10/581,670

Sylvain Bacquet

<b>Office Action Summary</b>	<b>Application No.</b> 10/581,670	<b>Applicant(s)</b> BACQUET ET AL.	
	<b>Examiner</b> Trinh Vo Dinh	<b>Art Unit</b> 2821

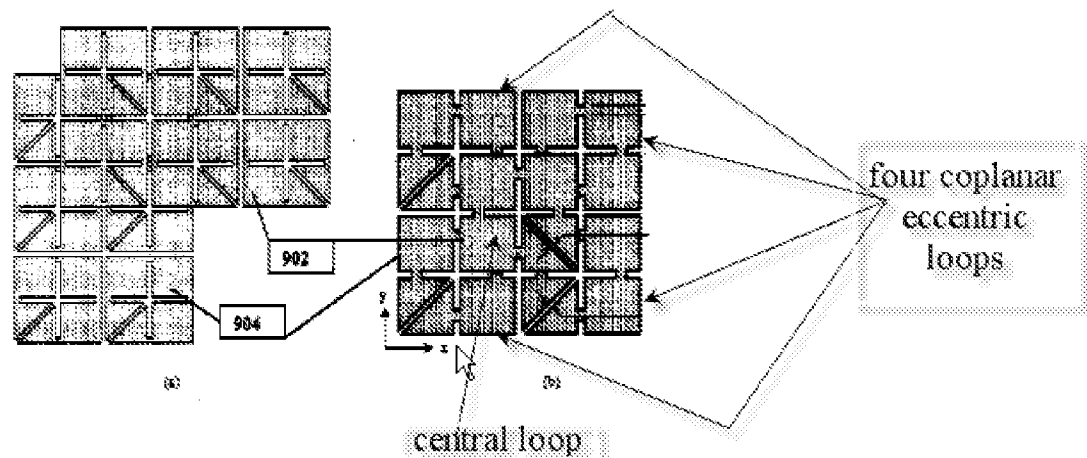
Respecting claim 1, Diaz discloses, in Fig. 17 or the below drawing, a central loop (a loop 804 in layer 902) and coplanar eccentric loops (four loops 804 in layer 904), the antenna comprises four adjacent coplanar eccentric loops, the centres of gravity of the eccentric loops being arranged substantially on the periphery of the central loop. Claim 1 recites the central loop (1) creating “a magnetic field essentially perpendicular to the antenna”, and “supplied in such a way as to create a rotating field predominantly in a plane parallel to the plane of the antenna”. Diaz discloses the same structural configuration as the claimed invention. Therefore, although not explicitly stated in Diaz, it is inherently that the central loop and four coplanar eccentric loop of Diaz would create a magnetic field essentially perpendicular to the antenna and create a rotating field predominantly in a plane parallel to the plane of the antenna as claimed.

Respecting claim 2-3, Diaz discloses the same structural configuration as the claimed invention. Therefore, although not explicitly stated in Diaz, eccentric loops (804 in layer 904) are associated in pairs of non-adjacent loops inherently generate electromagnetic fields of opposite phases in said pair, and the two eccentric loops of a pair are connected so that a same current is inherently flowing through them in opposite trigonometric directions.

Respecting claims 4-7, Diaz discloses the four eccentric loops are arranged symmetrically with respect to the centre of the central loop, and central loop and the eccentric loops (2) are substantially rectangular or triangular, an apex of each triangle being located in the central zone of the antenna (col. 9 lines 45-50).
